Idaho Technical Guidance Committee Meeting Agenda

Thursday, December 4, 2025

Appendix A

Technical Guidance Committee Meeting Minutes

Figure 2-8. Cutoff trench plan view.

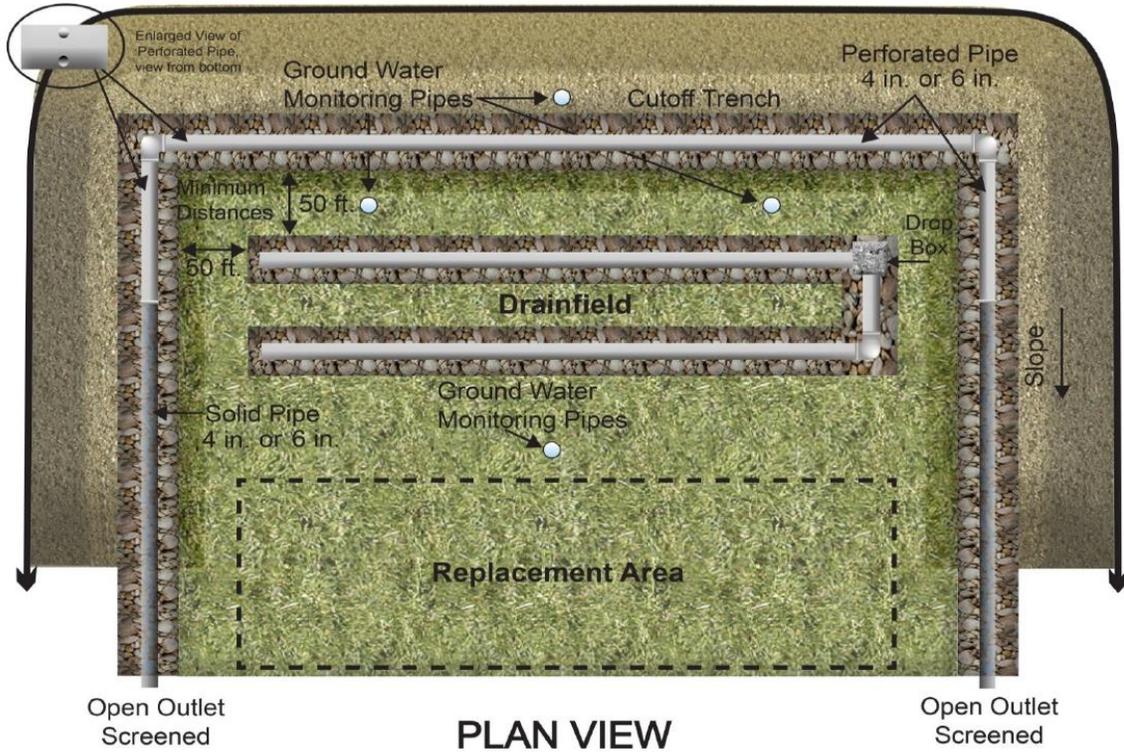
TGM Figure 2-8 Cutoff trench plan view (Appendix H)

- Revise Figure 2-8 to delete the 50-foot minimum separation distance depicted in the figure. The minimum separation distance from the drainfield to a cutoff trench is determined by Table 2-12 and varies from 9.5 feet to 120 feet.
- Vote on preliminary approval.
